SPECIAL MEETING NOTICE AND AGENDA
JOINT MEETING OF THE
MANSFIELD PLANNING AND ZONING COMMISSION
and
MANSFIELD INLAND WETLANDS AGENCY

Memo to: Planning and Zoning Commission
From: Linda M. Painter, AICP, Director of Planning and Development 
Date: August 2, 2012
Subject: Beacon Estates Section 2 Subdivision Design Process Submission (PZC File 1214-3)

Re: Beacon Hill Estates Section II **Conceptual Layout Plan**

OPEN SPACE SUBDIVISION PLAN

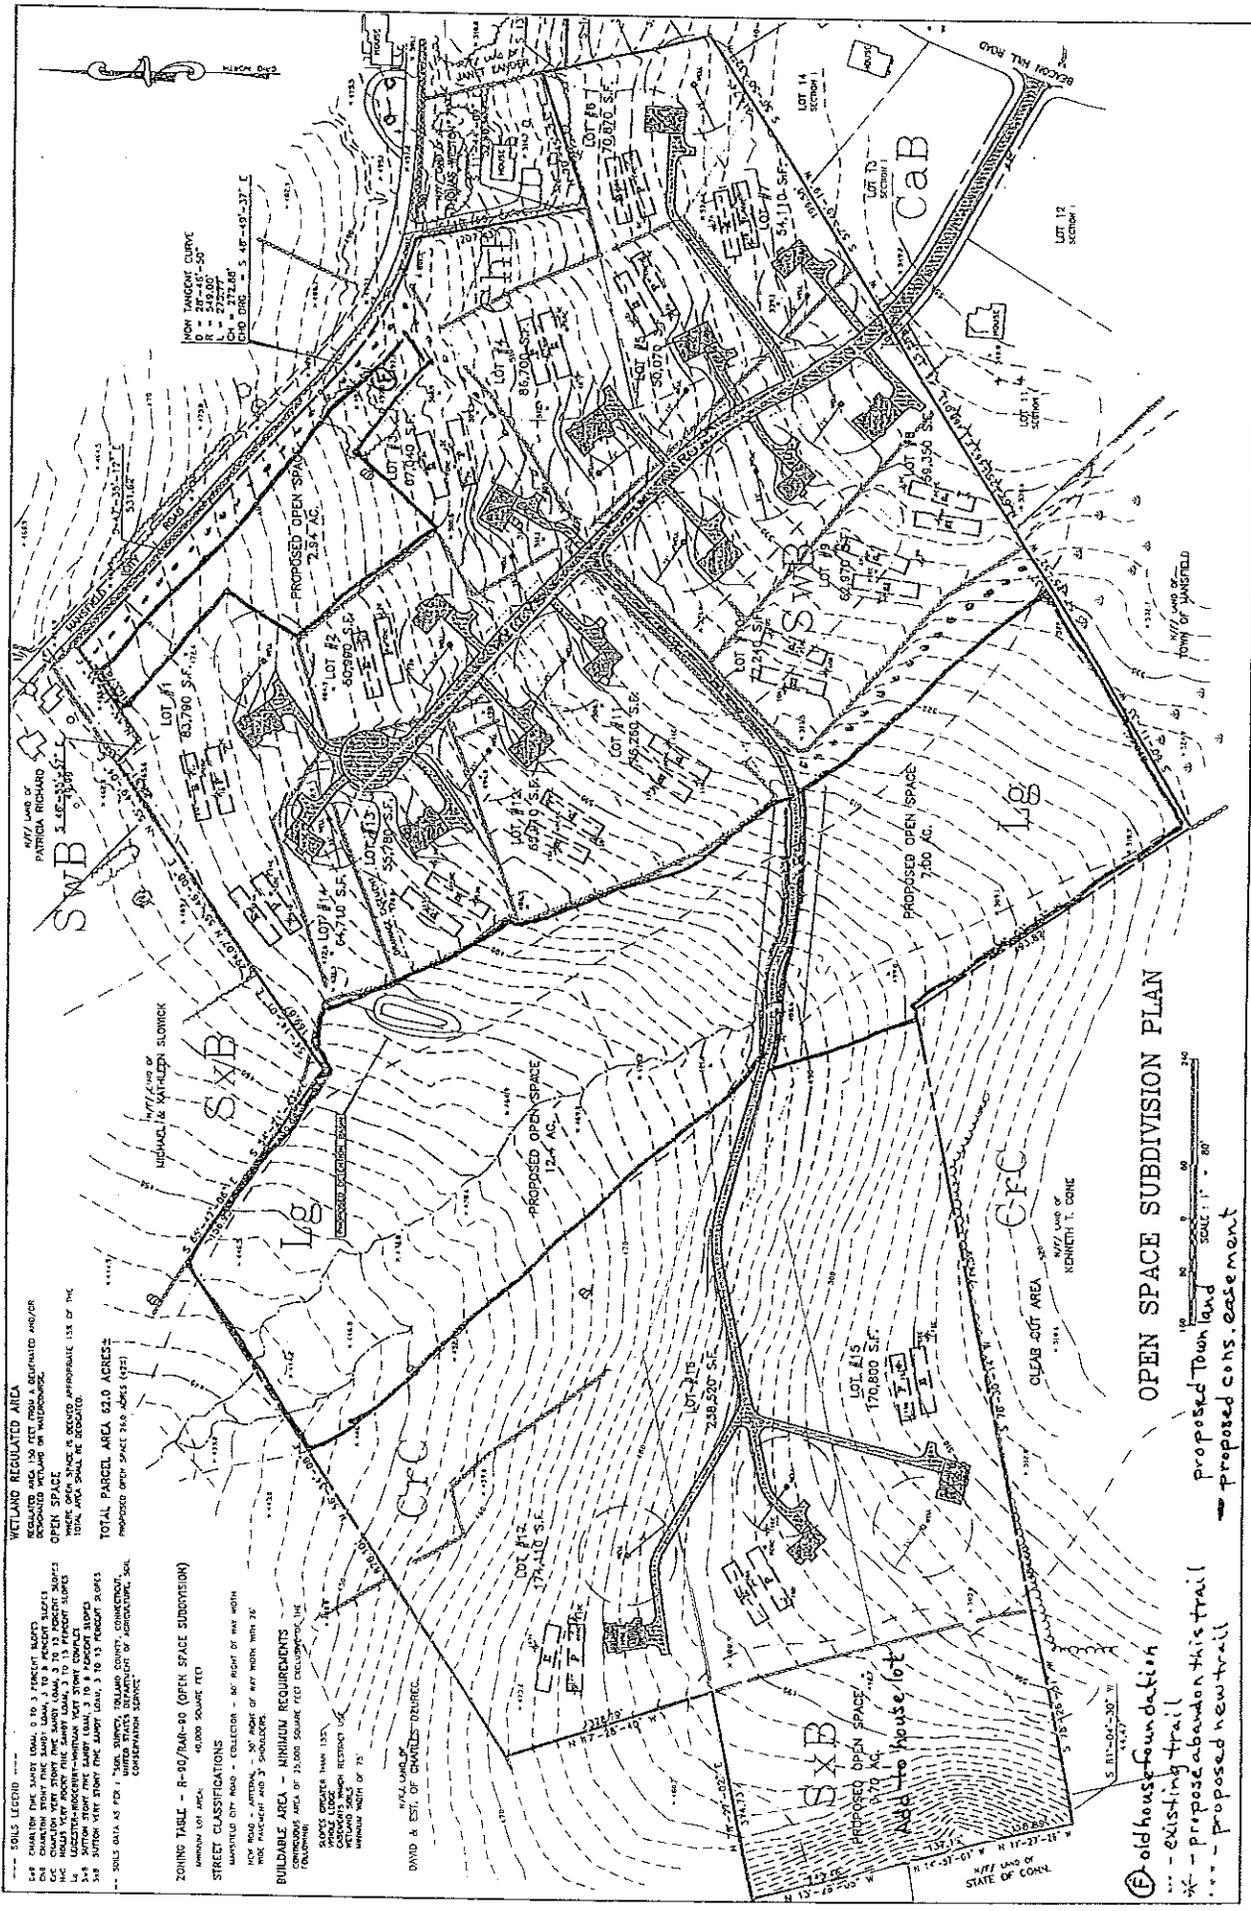
- 1) Recommend support for the **proposed conservation subdivision** with 14 house lots east of wetland.
- 2) Recommend **conservation easements** (see map) on

- A. proposed open space along north/south wetland area. Recommend that this area be protected by conservation easements on the house lots west of the north/south wetland.

- B. proposed open space area along Mansfield City Road. Recommend that this area be protected by conservation easements on house lots north of the proposed Wyllys Farm Road. In particular, Town ownership of the old house site and surrounding area is not recommended because of liability concerns about public access to potentially injurious items in this area. (Town ownership of a trail corridor along frontage of this area is recommended (see below).

- C. Proposed 3.5-acre open space parcel on South boundary. Note that this area cannot be granted to the Town without access because this would create a land-locked parcel. Recommend that this area be included in a house lot.

3) Recommend **Town ownership** (see map) of trail corridors to insure access to these trails into the future and avoid potential issues that could arise if there were trail easements on house lots instead.

A. Town to own farm lane leading from proposed Wyllys Farm Road to Mansfield City Road. Also a connecting trail corridor inside the stone wall along Mansfield City Road (to be no more than 15-feet wide). This would provide a trail connection from Wyllys Farm Road to the open space north of Mansfield City Road.

A. Town to own a 30-foot-wide trail corridor between existing Town open space in Section I and the farm lane (proposed shared driveway). This corridor would provide a trail connection from an existing trail in Section I to the proposed shared driveway on the farm lane.

B. ROW for public pedestrian access along part of the farm lane that is the proposed shared drive. This would connect the above trail with the proposed trail from Wyllys Farm Road to Mansfield City Road.

C. Recommend abandoning the existing trail on Lot 10 of Section I because it crosses the lawn of this home. The proposed trail would be a better alternative because it has stone walls as a buffer between the trail and the house lots.
